Closure Sampling and Analysis Plan for Medical Training Facility

Westover Air Reserve Base
Massachusetts

**RESPONSE TO COMMENTS ON DRAFT AND DRAFT FINAL
CLOSURE SAMPLING AND ANALYSIS PLAN**

**RESPONSE TO AFCEE, WESTOVER ARB AND MASSACHUSETTS DEP
COMMENTS TO THE DRAFT FINAL CLOSURE SAP FOR THE MEDICAL
TRAINING FACILITY SITE, WESTOVER ARB, MASSACHUSETTS**

FIGURE 2.2

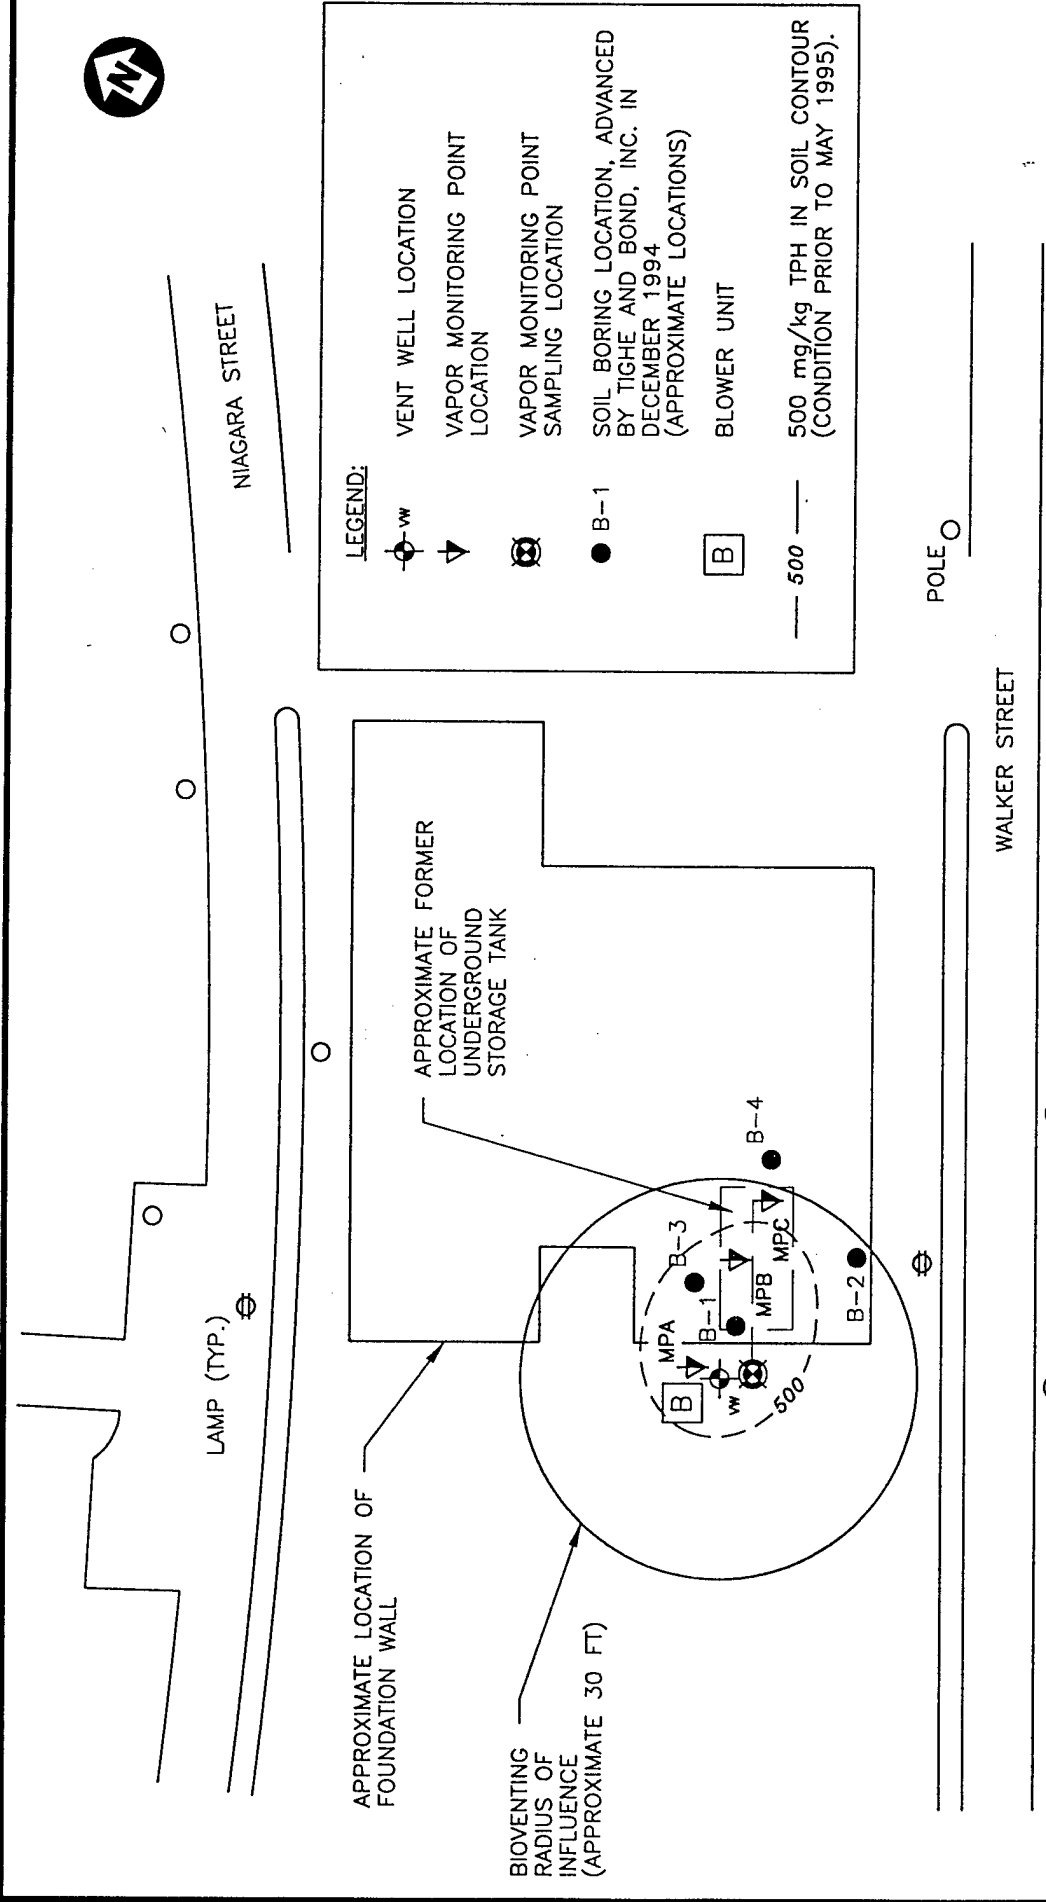
6. *As stated in the report, "the angled boreholes will be drilled at approximately a 45 degree angle, beginning 15 feet away from the building foundation." These boreholes will be completed to 30 feet below the ground surface, and 15 feet within the building foundation." On Figure 4-1 (soil sampling location) it appears that this will give you a sample at 15 feet under the foundation or in the middle of where the UST used to be located. How will the east (far) side of the*

former UST location be sampled? Will the entire "extent of the contamination" be defined for the RAO? The extent of the RAO should be documented vertically and horizontally.

The east end of the former UST area was sampled during an investigation by Tighe and Bond, Inc. in December 1994, location B-4 on Figure 2-2. This soil sample was collected from the 40 to 42 foot depth interval, was analyzed, and detected BTEX compounds below the method detection limit and TPH concentrations of less than 55 mg/kg. In addition, to further document the extent of contamination for the RAO, Parsons ES installed a soil vapor monitoring point (MPC) on the east end of the former UST location in April 1995. This location has shown low concentrations of field analyzed total volatile hydrocarbons (TVH) (less than 75 ppm). Therefore, Parsons ES excluded the collection and analysis of soil from this area because soil and soil gas samples have been collected from this area previously and the results showed low levels of contamination.
